Powerhead Lower End Cap - 225, 225 EFI, 3 Litre

Models Affected

Beginning with s/n 0G259668, the 225 carburetor, 225 EFI, and 3 litre Marathon/Sea Pro models have an improved lower end cap installed on the powerhead. The new end cap has a taller casting, 1171-9787-C1 cast on it, and two drive shaft seals instead of one.

Figure 1. Previous 1171-9787A-1 End Cap Assembly

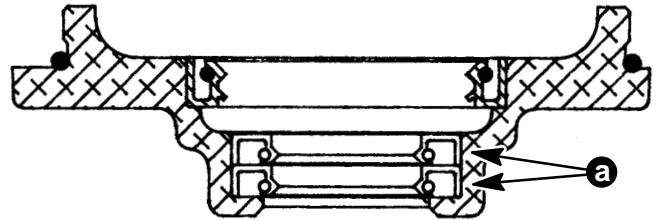
Any time a powerhead with the previous single drive shaft seal end cap assembly is removed, replace the end cap with the new two seal assembly. Stamp the powerhead with two punch marks (figure 3) to identify the installation of the new lower end cap assembly.

Figure 3. Starboard Side View

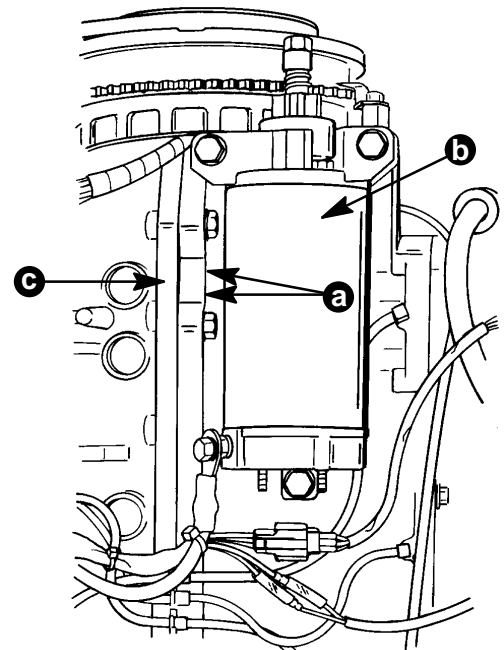
A Quicksilver replacement powerhead with the new end cap has two punch marks on the starboard side of the powerhead and/or a date code of X 065 95 and above stamped on the block.

IMPORTANT: Stamp the powerhead with two punch marks for future identification of the installation of the new end cap assembly. Refer to Figure 3.

Figure 4. Lower End Cap Removal

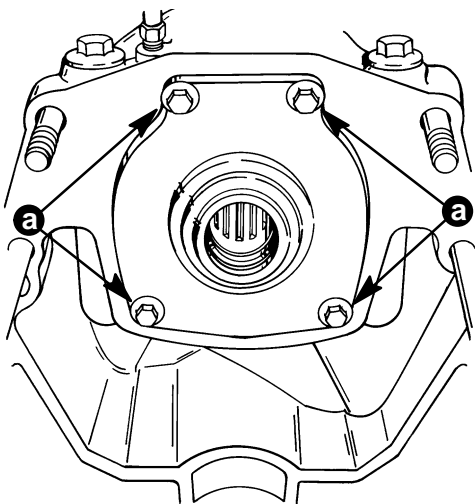
Remove the lower end cap assembly from the powerhead. It may be necessary to lightly tap the end cap to loosen.

Figure 5. Lower End Cap

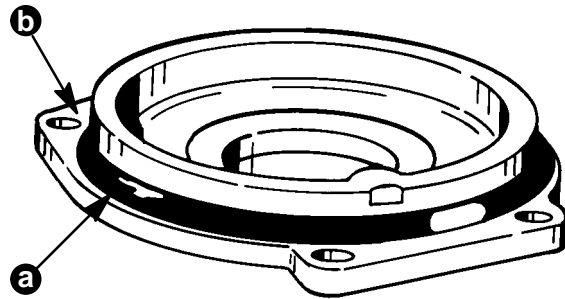
Apply a light coat of Perfect Seal (92-34227--1) to the end cap flange.

Lubricate the O-ring seal with Quicksilver 2-4-C with Teflon (92-825407A12) to aid in installation and reinstall the lower end cap assembly.

Assemble the end cap to the powerhead, reinstall the four (4) attaching bolts, and torque to 85 lb. in. (9.6 N·m).
